Re: Hall Community Park access and Warwick Alley Connection between Glasgow & Mackinnon

These comments will be provided to the city's decision-makers for consideration when they take action on the proposed project. These comments do not specifically address the sufficiency or adequacy of the EIR in identifying and analyzing the project's environmental impacts and are therefore noted for the record.

Public comment on Draft Environmental Impact Report for Proposed Park on Hall Property
Case # 04-197 CDP/MUP SCH # 2004121126

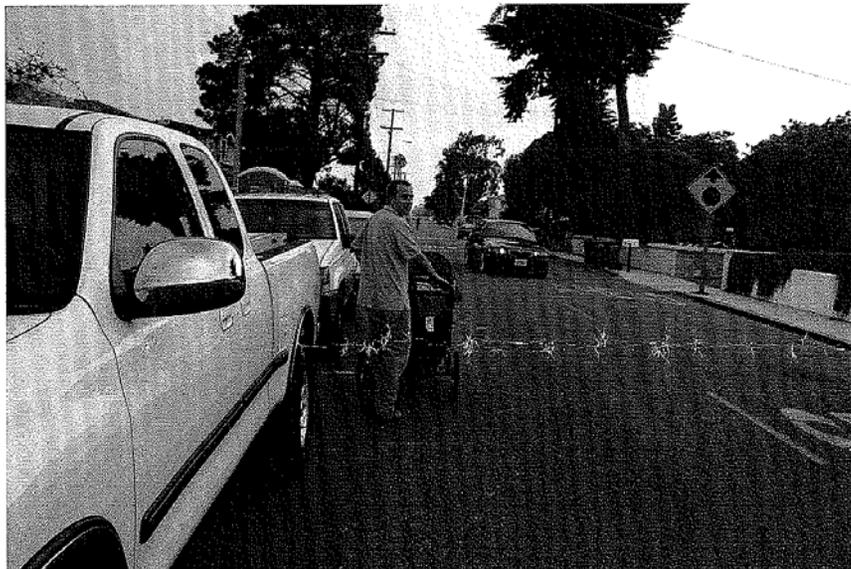
The combination of high vehicle traffic, speeding, swerving vehicles and pedestrians/bicyclists in the road due to the narrow sidewalks I feel equates to a very dangerous situation, and would like to see it addressed.

- Mackinnon Avenue West Side Access: Parking on the west side requires walking in the middle of the street causing cars to swerve into the oncoming lane to pass.
- Mackinnon Avenue West Side Access #2: Pedestrian and bicycle traffic are forced into the middle of the road.
- Mackinnon Avenue East Side Access: Sidewalk access does not permit strollers or bicycle traffic to safely pass, so again both are forced into the traffic lane.
